City of Detroit
Inter-Departmental Communication

RE: Petition No. 1416
Request To Convert To Easement The East/West And North/South Alley In The
Block Bound By Area Bound By St. Aubin, Gratiot, Dubois, And E. Vernor HWY.

REQUEST TO CONVERT TO EASEMENT
 THE EAST/WEST AND NORTH/SOUTH
 PUBLIC ALLEY, 21.17 FT. WD.
 IN THE AREA BOUND BY
 ST. AUBIN, GRATIOT, DUBOIS AVE.
 AND E. VERNOR HWY.

CITY OF DETROIT CITY ENGINEERING DEPARTMENT SURVEY BUREAU	
JOB NO.	01-01
DRWG. NO.	X 1416

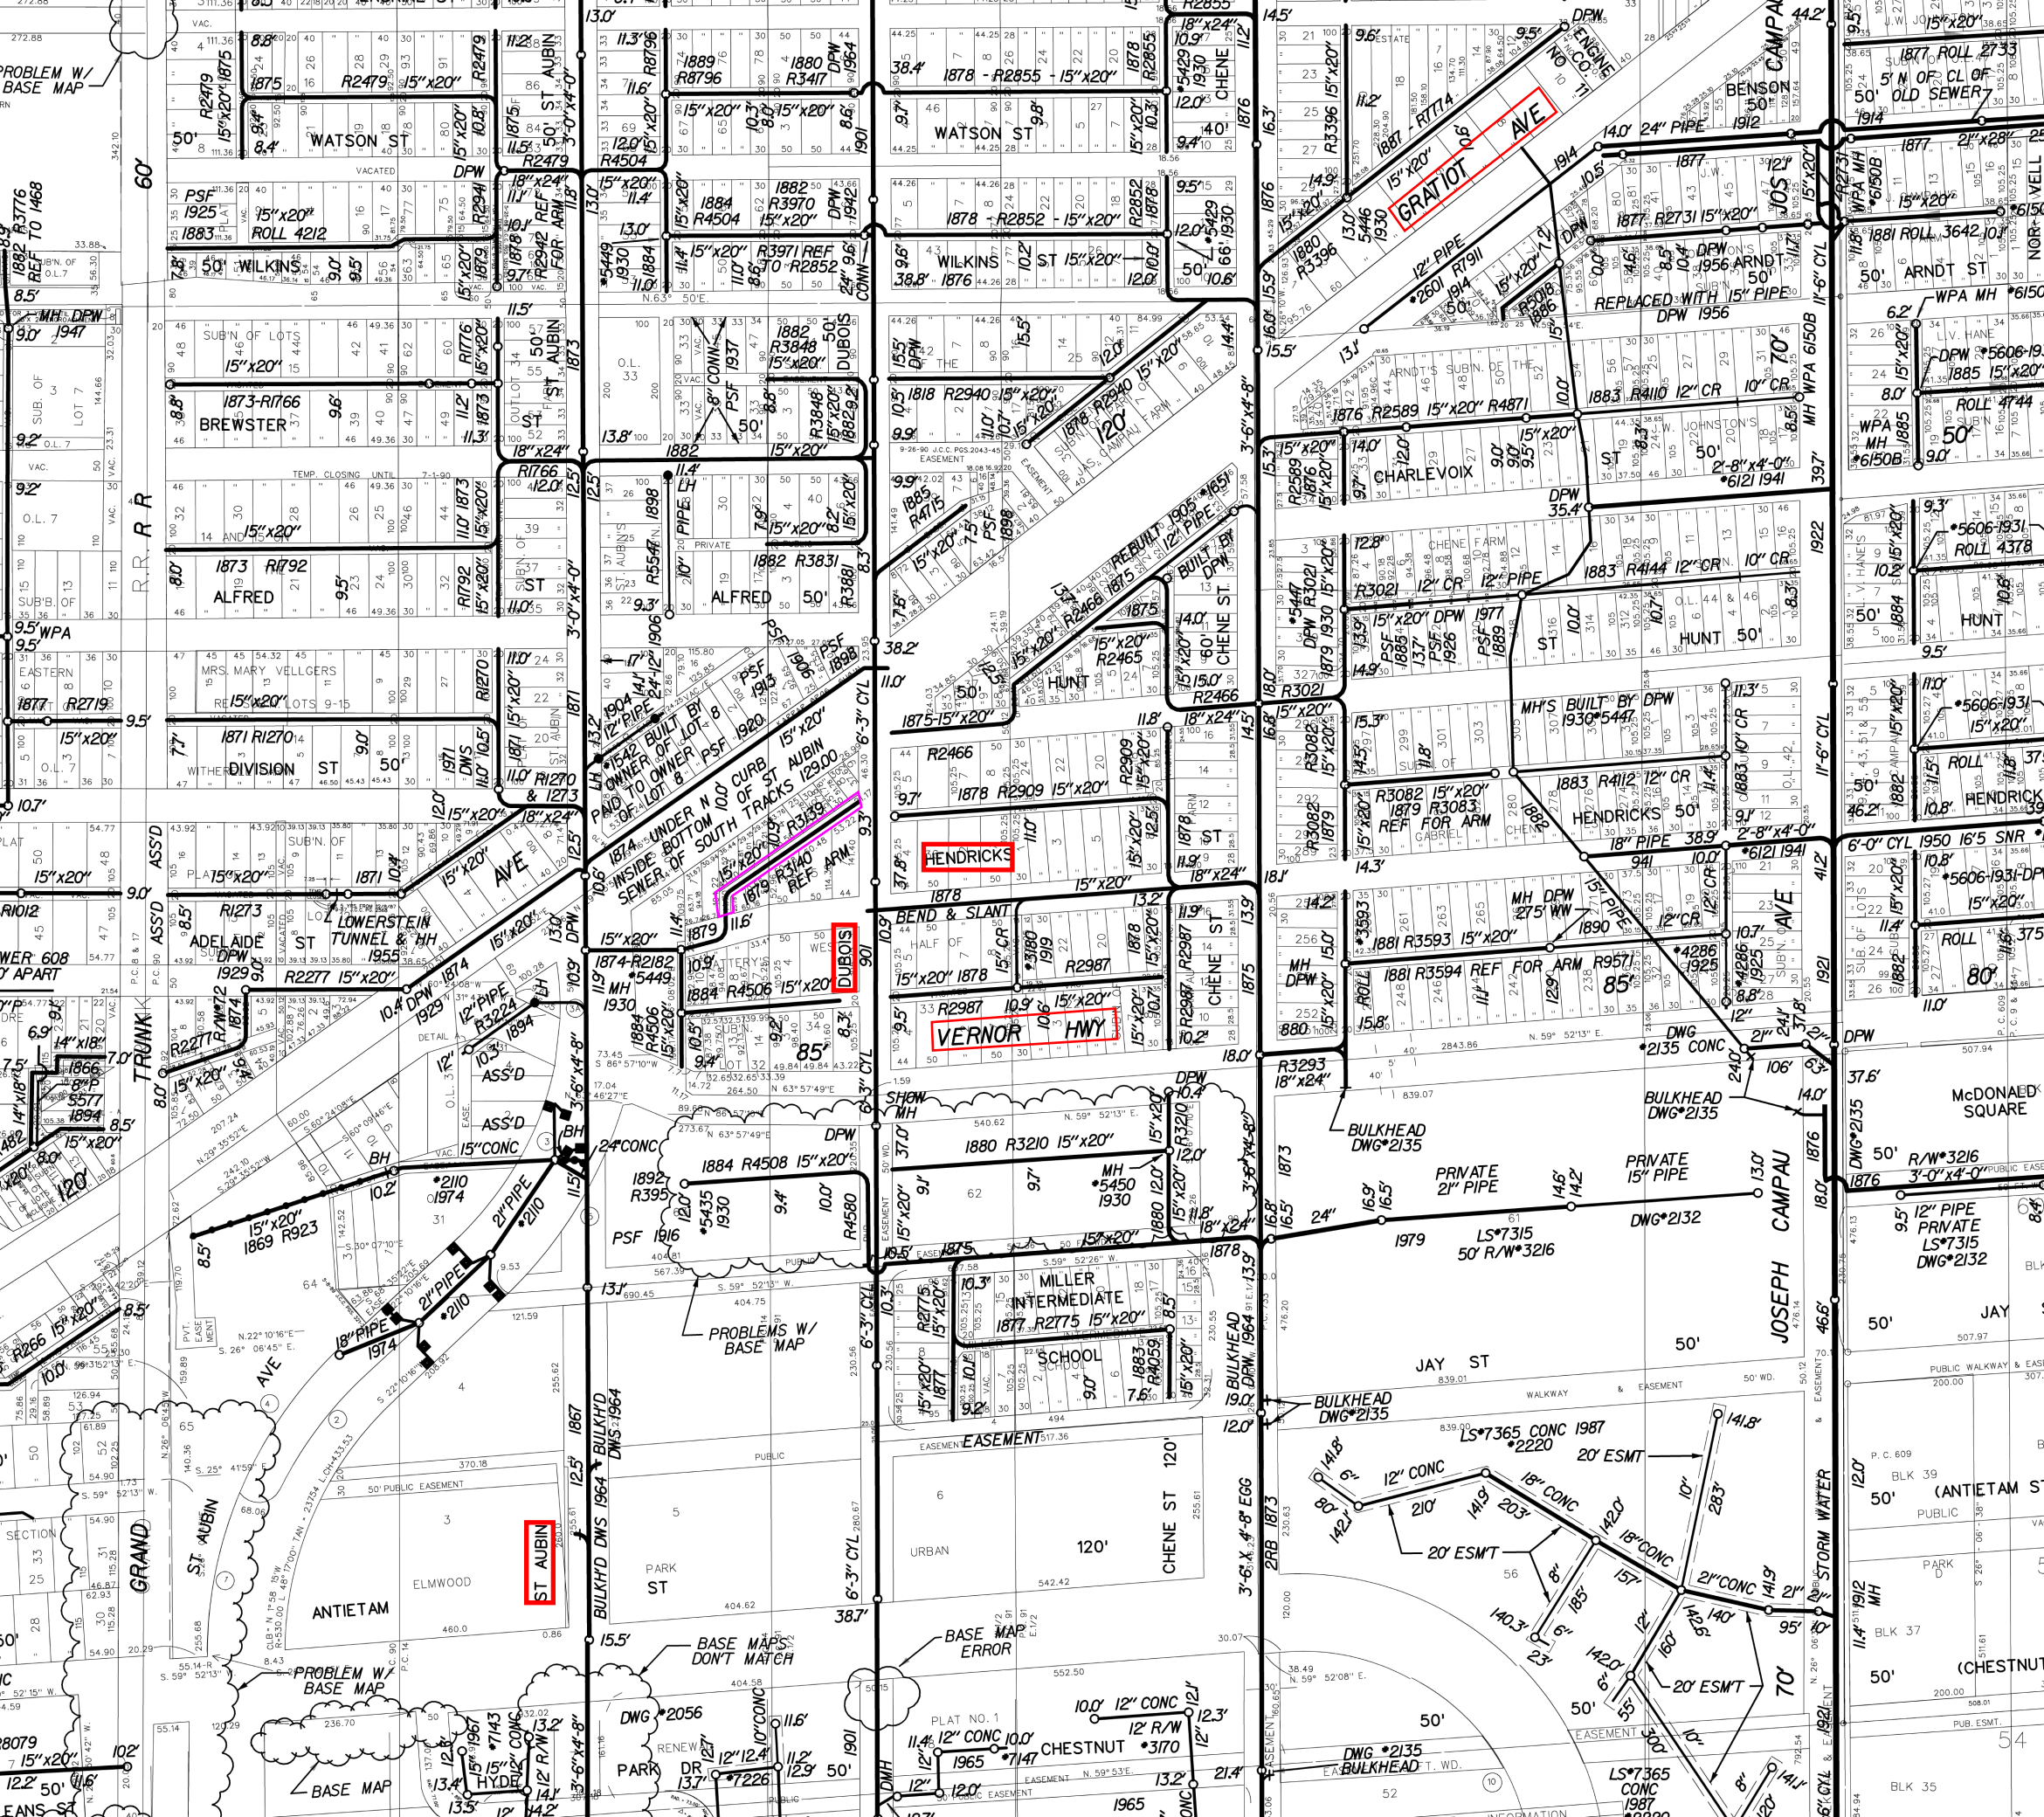
- Our records indicate that there is a sewer in the requested easements. DWSD has no objections to the requested conversion to easements provided that the attached Provisions for Conversion to Easement are strictly followed.

1. An easement, the full width of the existing right of way, is reserved for the Detroit Water and Sewerage Department for the purpose of installing, maintaining, repairing, removing, or replacing any sewers, water mains, fire hydrants and appurtenances, with the right of ingress and egress at any time to, and over said easement for the purpose above set forth.

Free and easy access to the sewers, water mains, fire hydrants and appurtenances within the easement is required for Detroit Water and Sewerage Department equipment, including the use of backhoes, bull dozers, cranes or pipe trucks, and other heavy construction equipment, as necessary for the alteration or repair of the sewer or water main facilities.

2. Said owners of the adjoining property, for themselves, their heirs and assigns, agree that no building or structure of any nature whatsoever, including fences, porches, patios, balconies, etc., shall be built upon or over said easement, or that no grade changes or storage of materials shall be made within said easement without prior written approval and agreement with the Detroit Water and Sewerage Department.
